Product Change Notification

113253 - 00

Change Notification #: 113253 - 00
Change Title: Intel® Server System R1208GZ4GS9
PCN113253-00, Product Design
Update the System Rear Panel
Date of Publication: September 23, 2014

Figure One

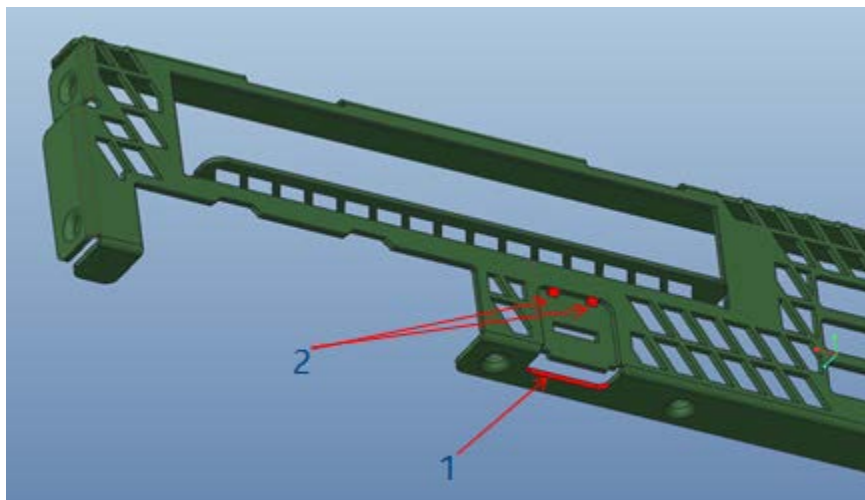
1. Add a connection at the bottom of the RMM4 (Remote Management Module 4) slot to improve structure strength. See item 1 in the Figure One.
2. Update the one big center joint to two smaller joints so that the joints will not conflict with the LAN cable connector latch. See item 2 in the Figure One.

Figure Three

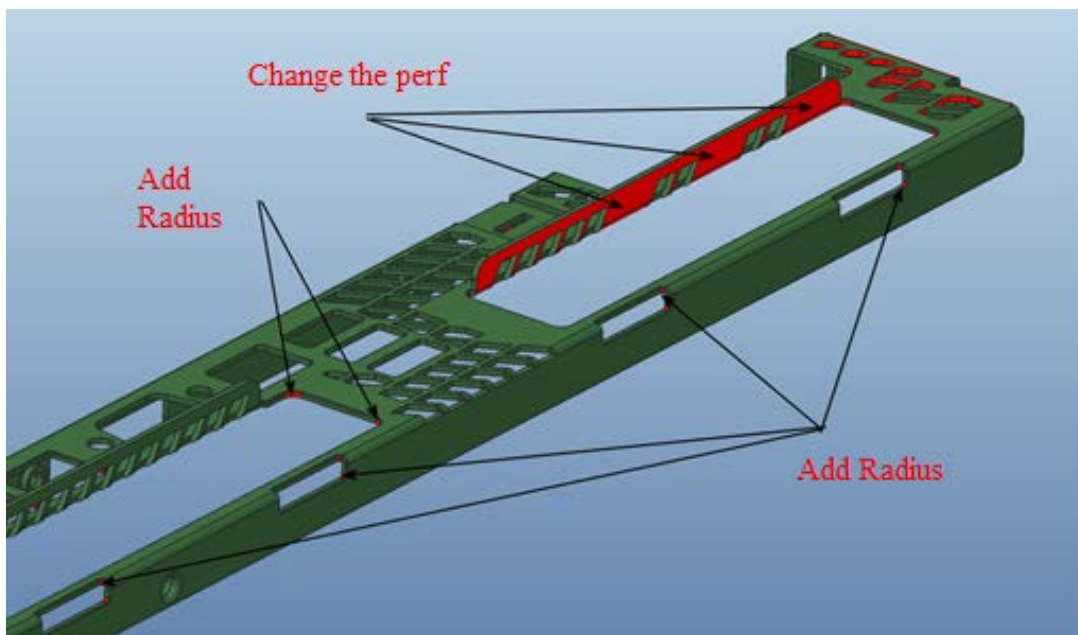
4. Update the perf and add radius to improve structure strength. See the Figure Three and Four.

Figure Five

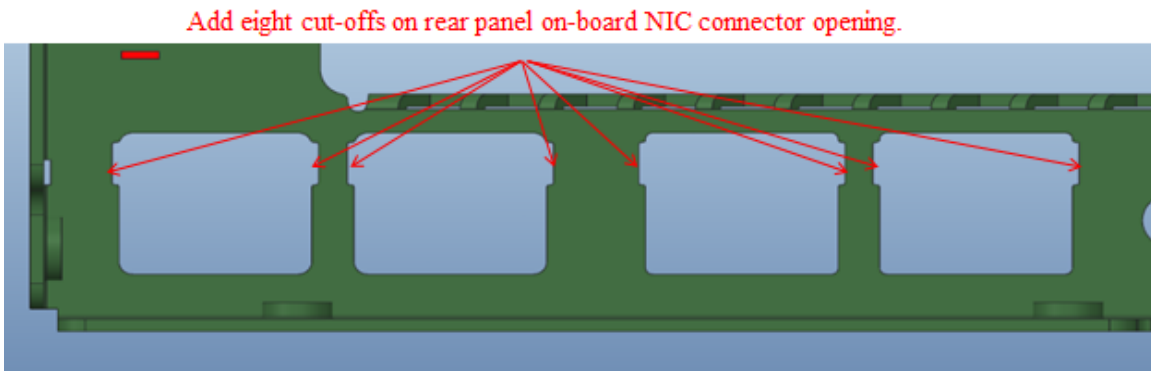
5. Add eight cut-offs around the on-board NIC (Network Interface Controller) openings to improve the LED visibility. See the Figure Five.
